1 Q. **Reference: Request for Information NP-NLH-023.**

2 In its 2021 Capital Budget Application, Additions for Load – Wabush Substation Upgrade, Section
3 4.2 Evaluation of Alternatives, Hydro identified and evaluated a three transformer alternative
4 and a two transformer alternative. Hydro stated for the two transformer alternative that “the
5 estimate for this alternative is approximately \$12.2 million and was rejected as not being the
6 least-cost alternative.” Hydro further stated “Hydro recommends the Wabush Substation
7 Upgrade – Three Transformer Configuration option (Alternative 1). This is the least-cost
8 alternative which addresses transformer capacity concerns and also addresses protection and
9 communication deficiencies within the station.”

**Chart 1: Alternative Comparison – Cumulative Net Present Value
Labrador West 46 kW Distribution Expansion – Wabush Substation Upgrades**

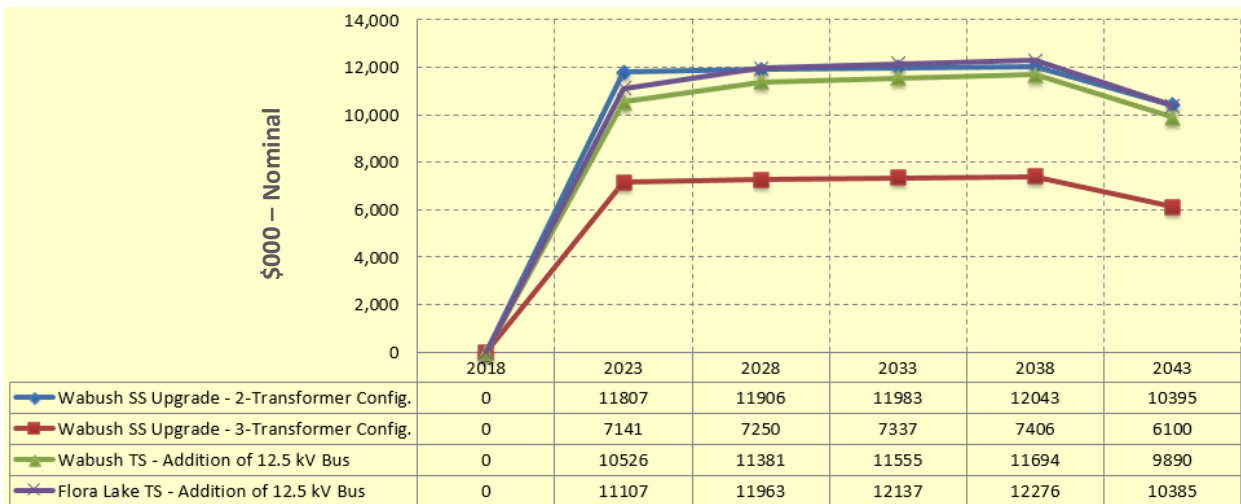
10 Please provide the net present value analysis comparing the two transformer and three
11 transformer alternatives that demonstrates that the three transformer alternative was the least-
12 cost alternative.

2 A graphical representation of the cumulative net present value of each alternative from the Year
3 2018 to 2043, which demonstrates that the three-transformer alternative was the least-cost
4 alternative is provided in Chart 1.
